# Service Bulletin

Bulletin No.: 18-NA-374

**Subject:** Low Oil Light On

Brand:	Model:	Model Year:		VIN Breakpoint:		Engine:	Transmission:
		from	to	from	to		
Cadillac	CTS	2014	2019	K0121280	EOP	2.0L (RPO LTG)

5181559

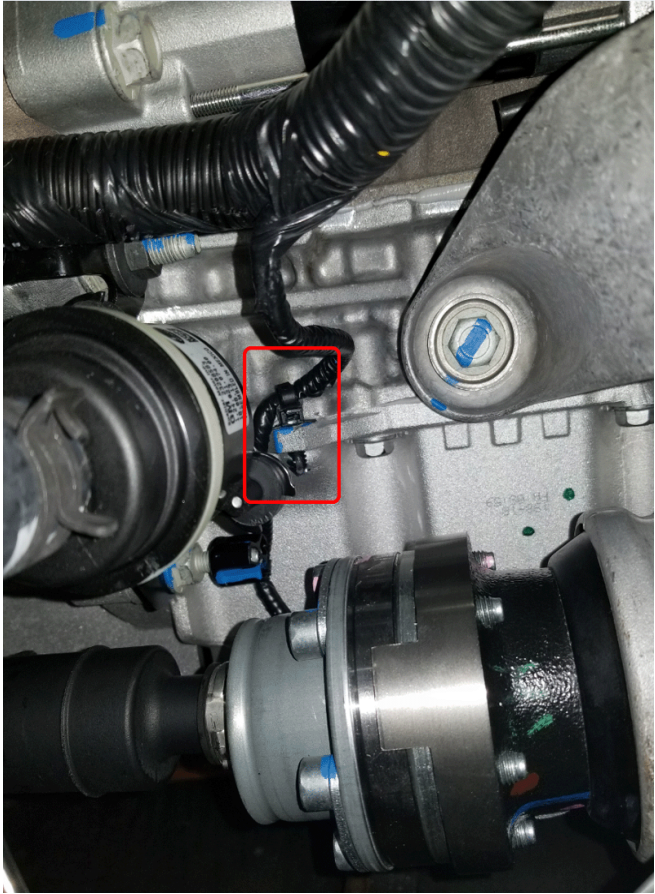
<b>Involved Region or Country</b>	North America, Europe, Japan, Middle East, Russia, Israel, South Korea, China
<b>Additional Options (RPOs)</b>	AWD (F46)
<b>Condition</b>	Some customers may comment that the Low Oil Light is on.
<b>Cause</b>	This condition may be caused by the oil level sensor wiring harness clip installed incorrectly, causing the harness to become too long and contact the driveshaft.
<b>Correction</b>	<p>If the above condition has been validated, inspection of the wiring harness must be done.</p>

<p><b>Note:</b> Original routing of the harness has the clip being installed from the bottom. Correction is to reverse the direction of that clip.</p> <ol style="list-style-type: none"> <li>1. With a suitable light, inspect the wiring harness point of contact at the driveshaft and positioning of the clip.</li> <li>2. Repair the harness as needed.</li> </ol> <p>⇒ Refer to <i>Wire to Wire Repair</i> in SI.</p> <ol style="list-style-type: none"> <li>3. Using Woven Polyester Electrical Tape (PET), tape all the contact points of the harness ensuring that the tape is applied in a double layer.</li> <li>4. Reposition the harness clip from the top down as shown in the graphic above.</li> </ol> <p>⇒ Verify the harness to driveshaft clearance. Adjust as necessary.</p>
--	--
